Re: Riverside Station/355 Grove Street and 399 Grove Street / #26-20 and #27-20

Riverside Station

Response to Comments from Land Use Committee Public
Hearing on 4/7/2020

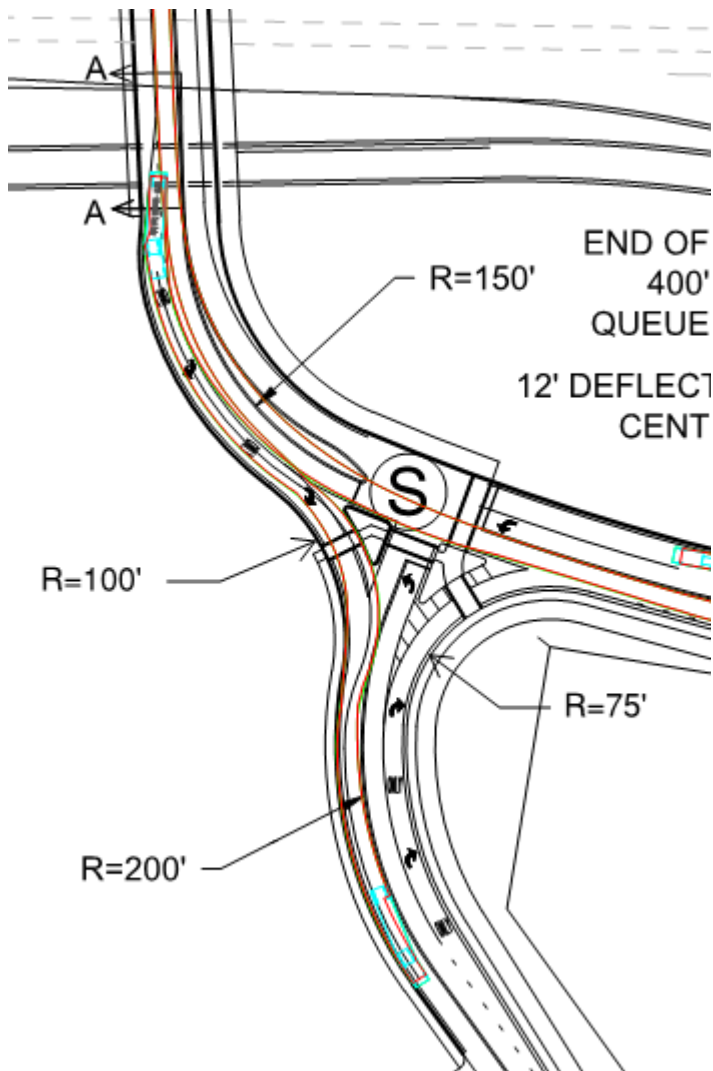
Councilor Bowman: I am worried about the right-turn slip lanes at the new Grove Street signalized intersection near the location of the current Hotel Indigo. There's a potential for vehicles to speed through the slip lanes and create an unsafe environment for pedestrians and bicyclists.

Grove Street under existing conditions is essentially a straight roadway with no stop signs or traffic signals that would slow the through eastbound and westbound movements along the roadway. The existing 85th percentile speeds on Grove Street is 32 mph in both the eastbound and westbound directions. The uncontrolled nature of Grove Street and the high speeds of the through movements is coupled with a short northbound off ramp from Route 128 and a free (straight) right turn slip lane from the Route 128 northbound off-ramp onto Grove Street eastbound that encourages vehicles to exit the interstate at high speeds and not slow down as they enter Grove Street. This creates significant issues for access and egress to the condominium complex located 100 feet east of the off-ramp slip-lane and for the crosswalk across Grove Street located another 100 feet east of the condominium driveway.

Under the proposed improvement plan, significant changes to the roadway network are being proposed that will specifically address the concerns raised above. Grove Street will no longer be linear eastbound and westbound, and controls to slow down traffic are being added along the roadway at the intersections with the Route 128 southbound ramps (roundabout), at the new Grove Street Extension (traffic signal), and at the Site Driveway (traffic signal). In addition, the right-turn slip lanes off the Route 128 northbound and southbound off-ramps are being eliminated, forcing vehicles to slow down before turning onto Grove Street. The addition of controls along the Grove Street corridor and the revised layout of the street (non-linear) will slow traffic activity over the existing conditions.

A side-by-side of the existing conditions and the proposed layout is presented below.

Proposed Bike Circulation Alternative 'A'

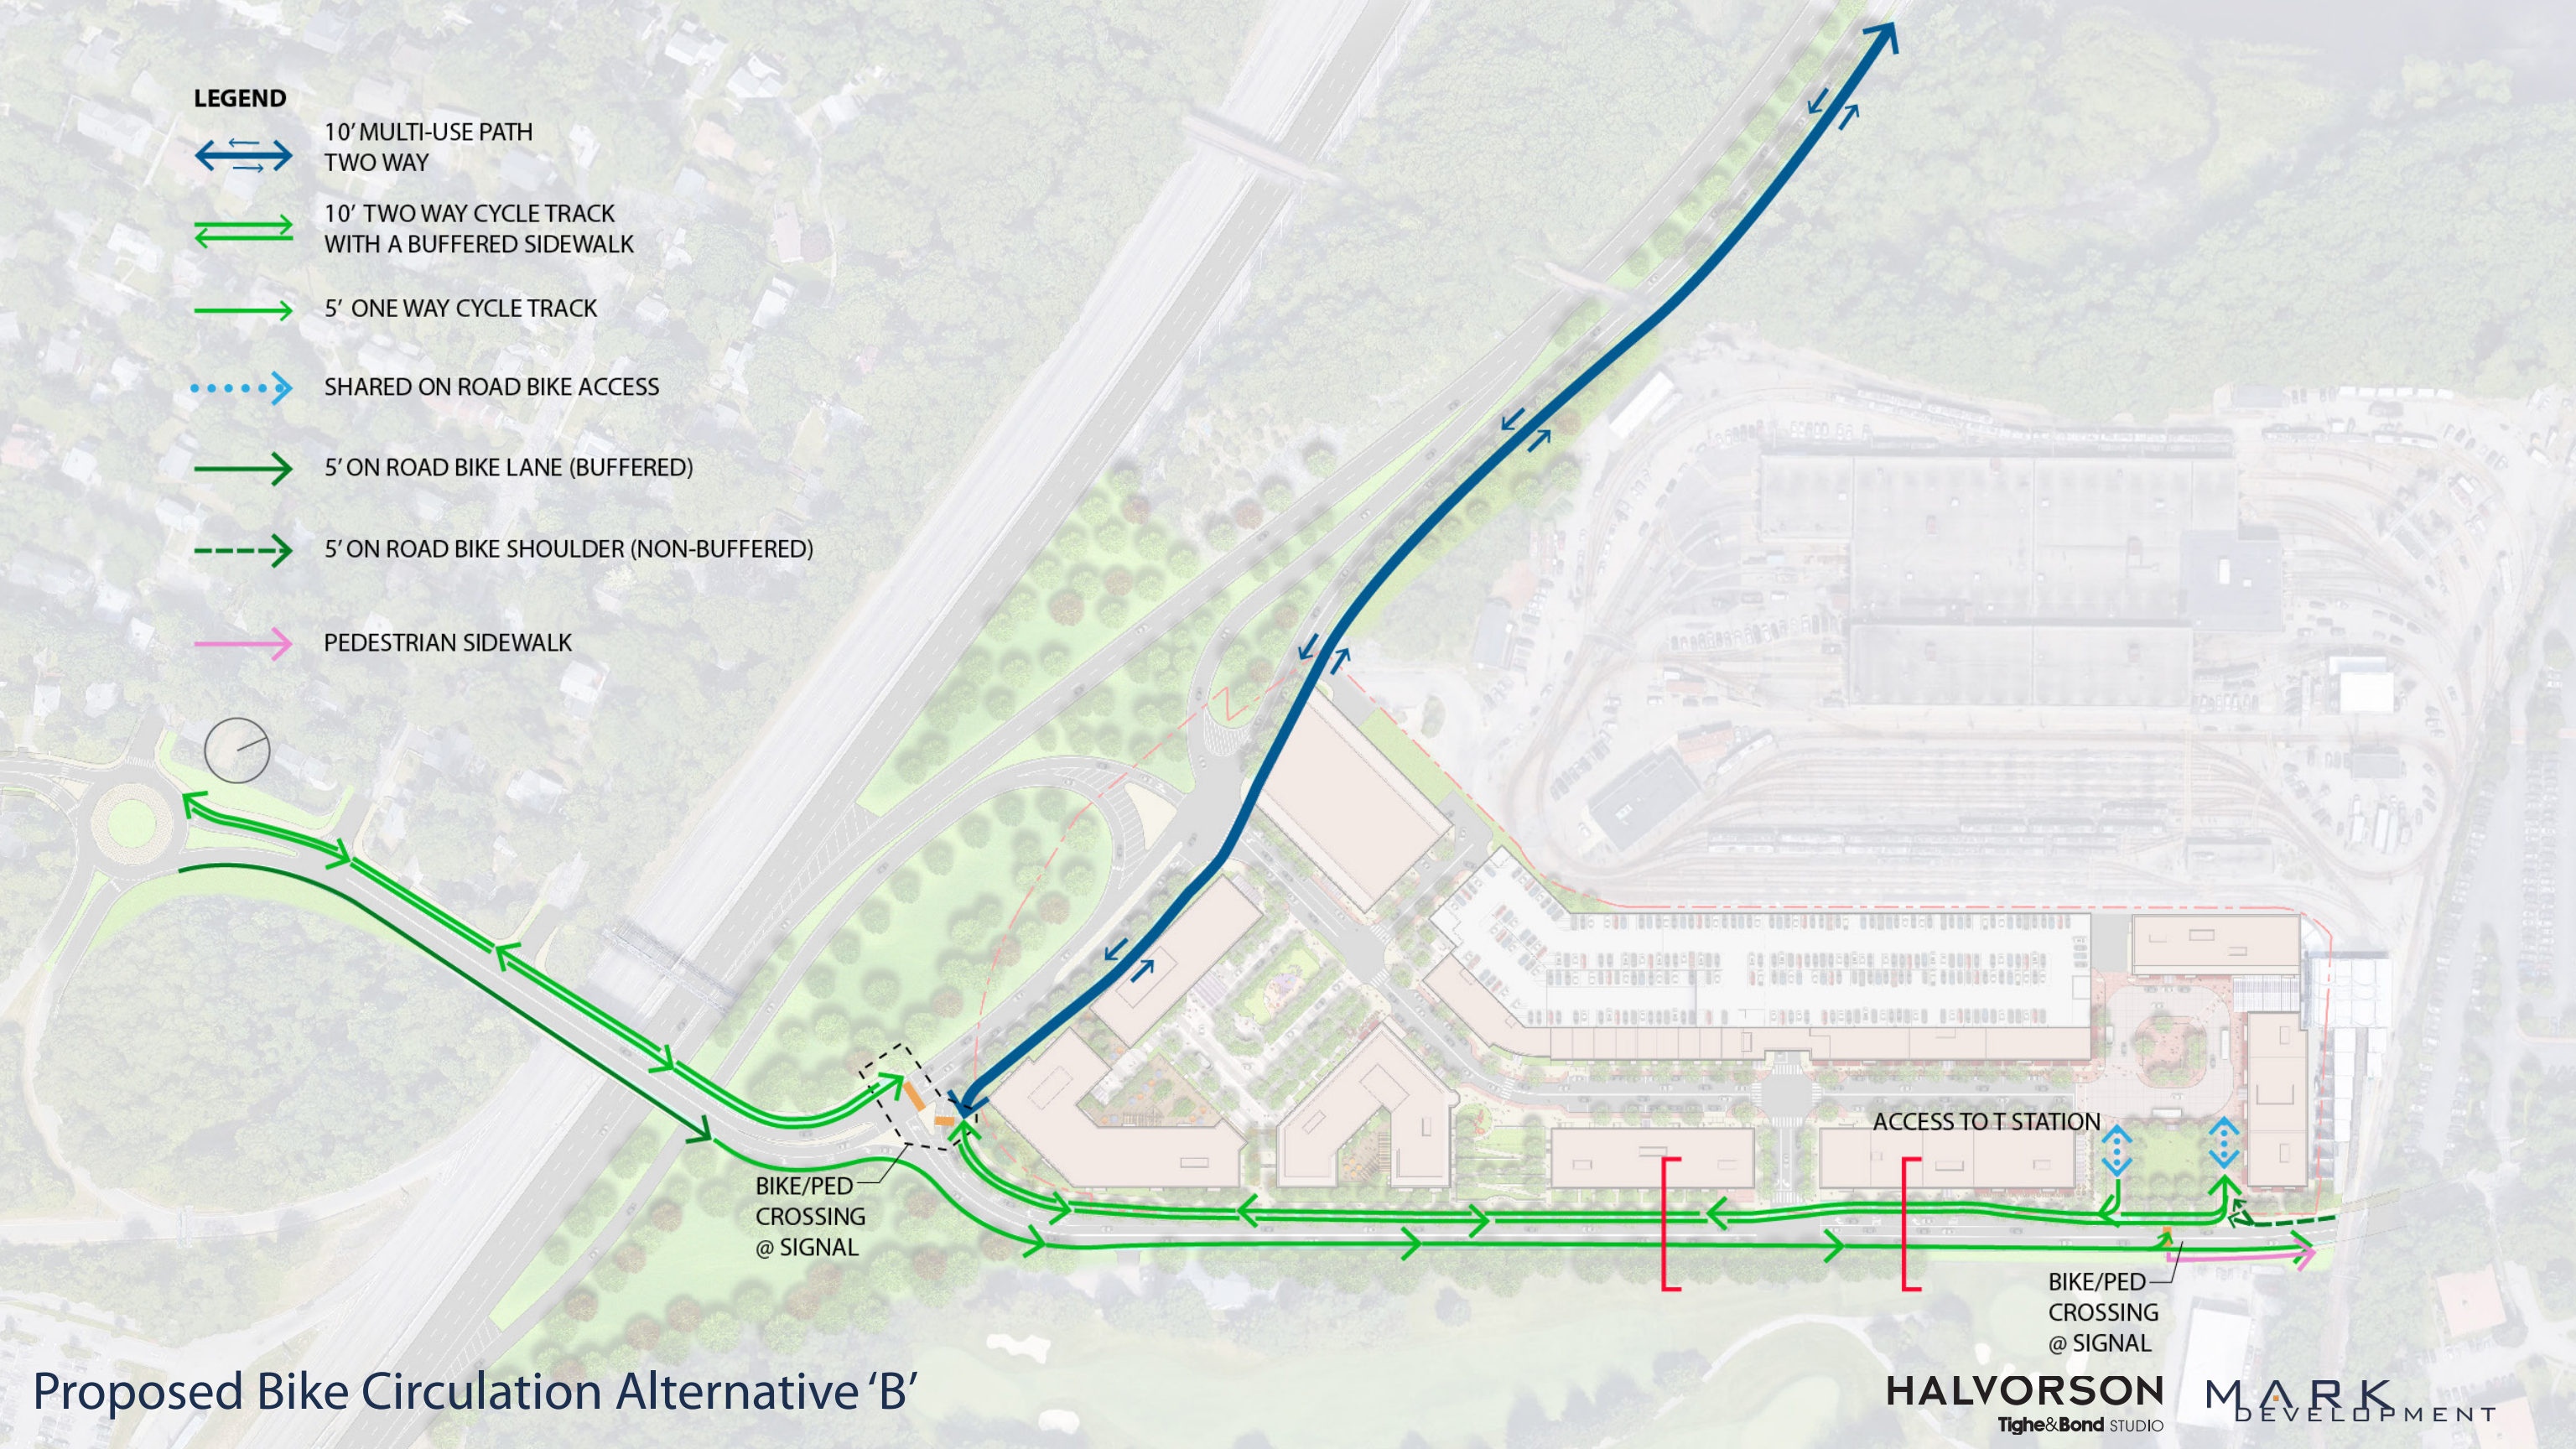
Grove Street is 26 feet wide. What is its width after the project, and if we further reduce it because of the bike lane, what would it be?

A detailed summary is included in **Attachment B**, which includes three alternatives. Alternative A (currently proposed, Alternative B (raised bike lane as requested by the Planning Department), and Alternative C (eliminating the bike lane).

Attachment C

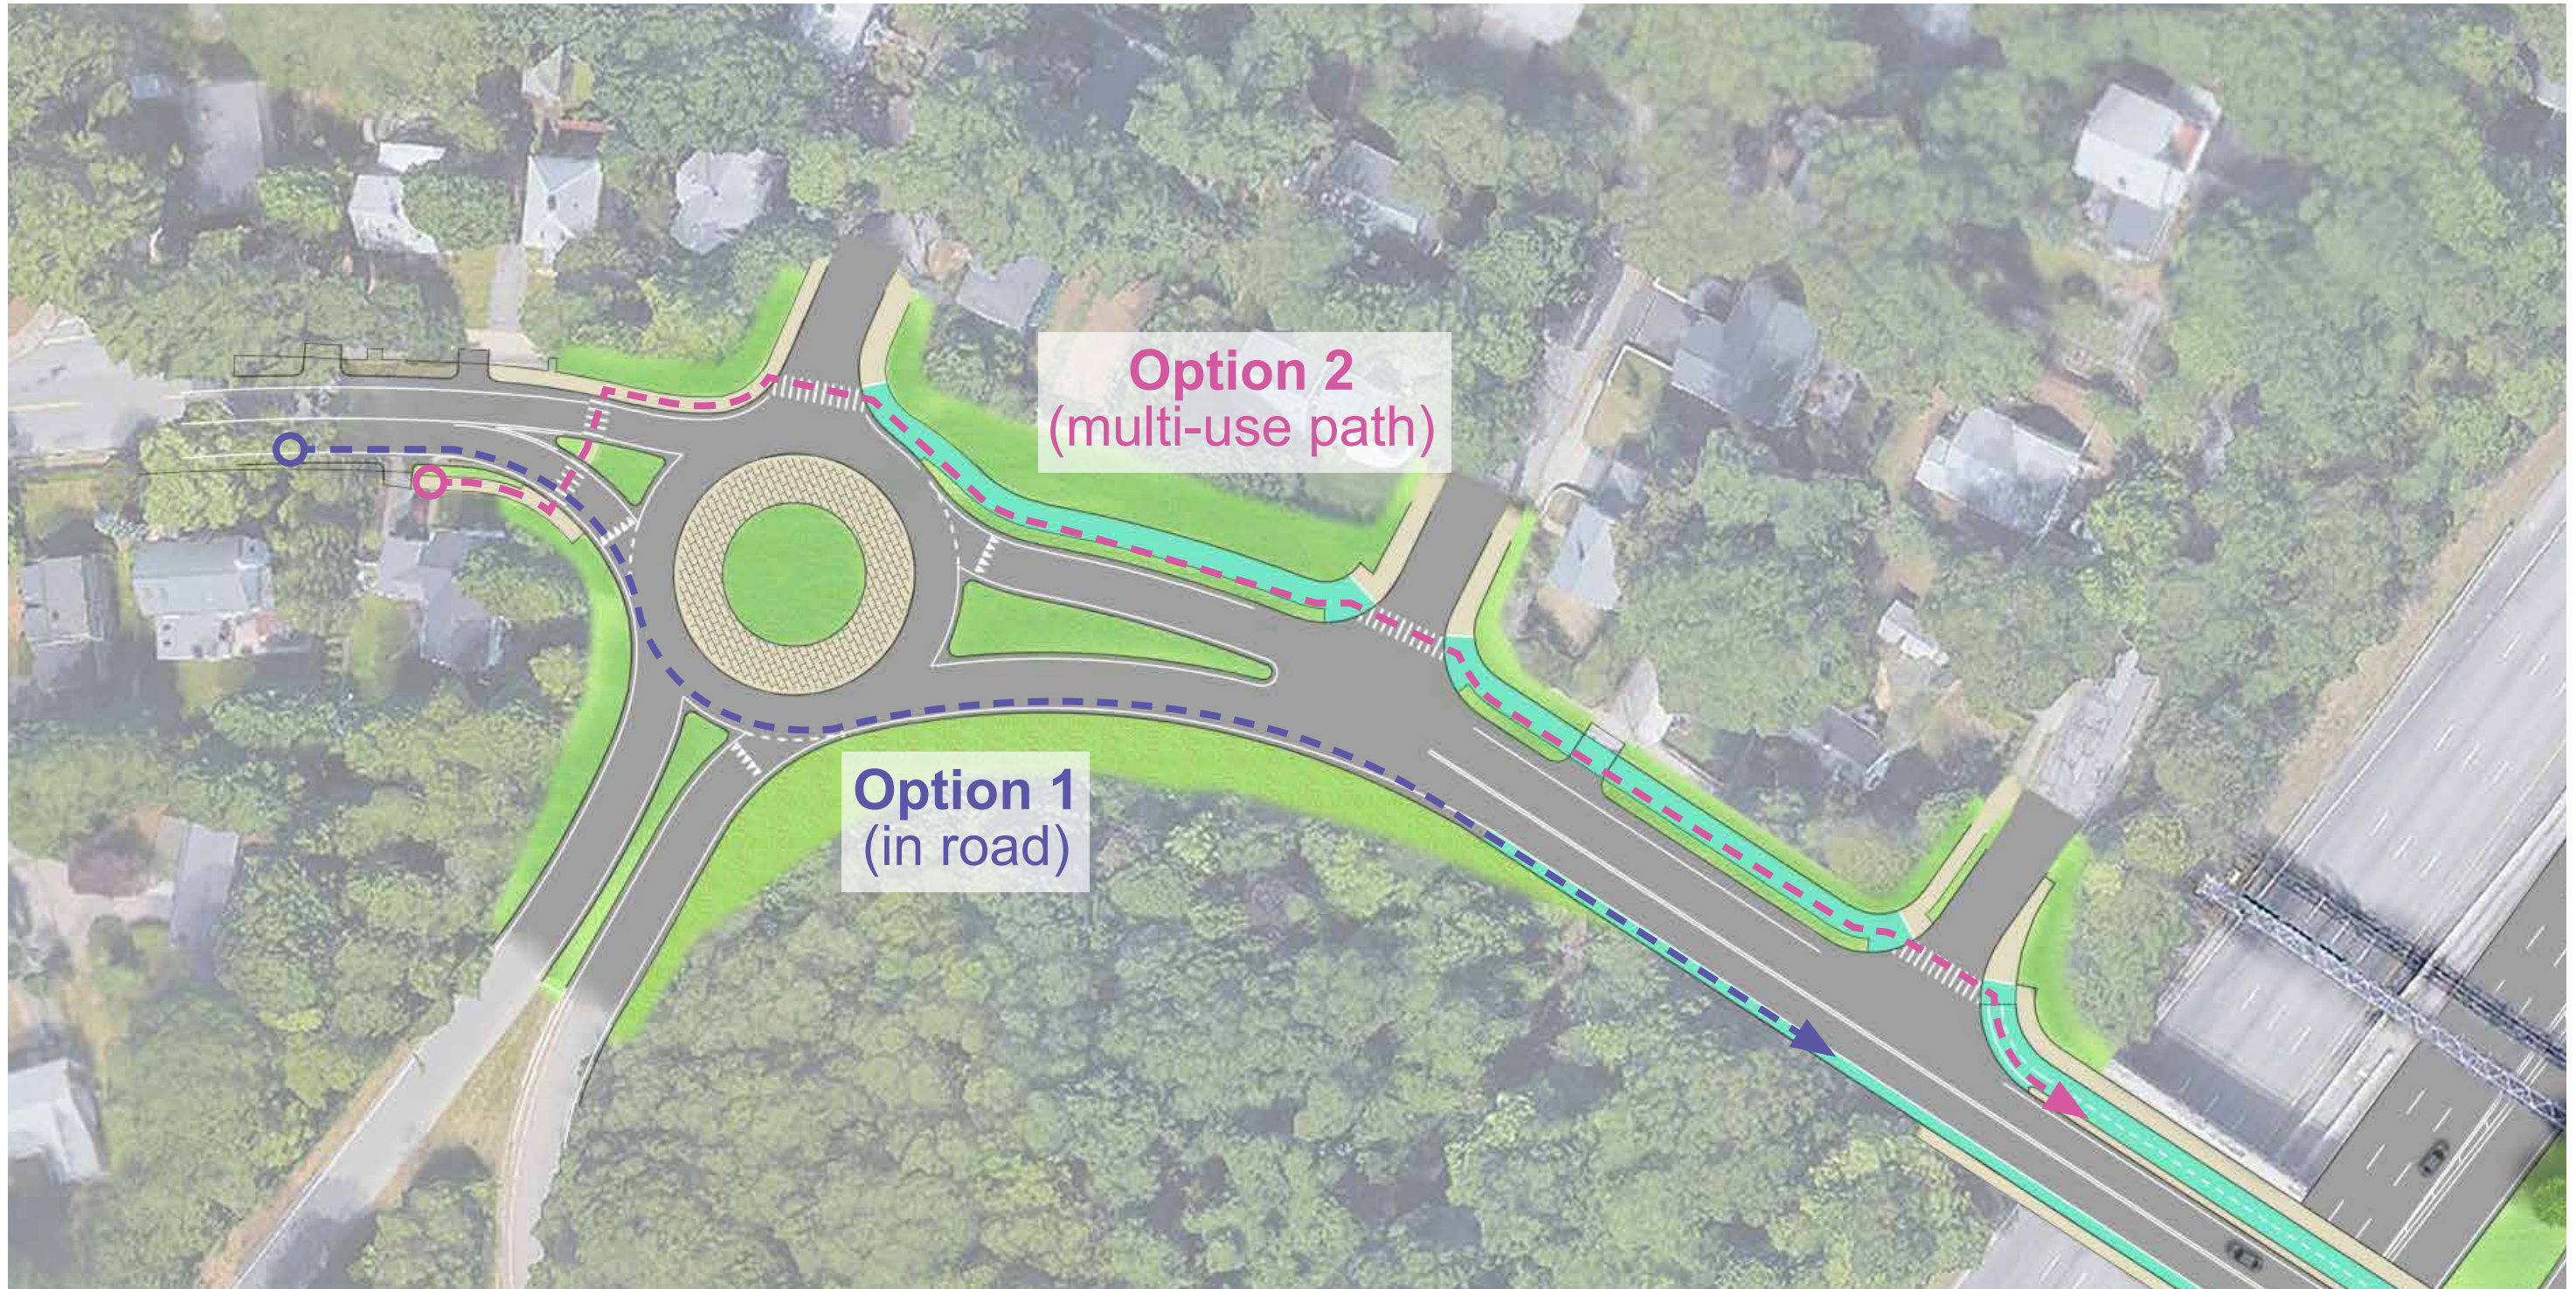
I still don't understand how it can be safe to bike through the roundabout. Also, by continuing the lane to Hancock Street in Auburndale – how do we finance that?

A bicycle can transition through the roundabout in one of two ways. First, they could remain in traffic northbound as they would be when they approach the roundabout and then they stay in traffic and transition into the new northbound bike lane on the bridge. Second, they could stop at the roundabout and cross in the crosswalk over to the 2-way cycle track and proceed on the other side of Grove Street across the bridge. A diagram of these two options is demonstrated in [Attachment C](#).
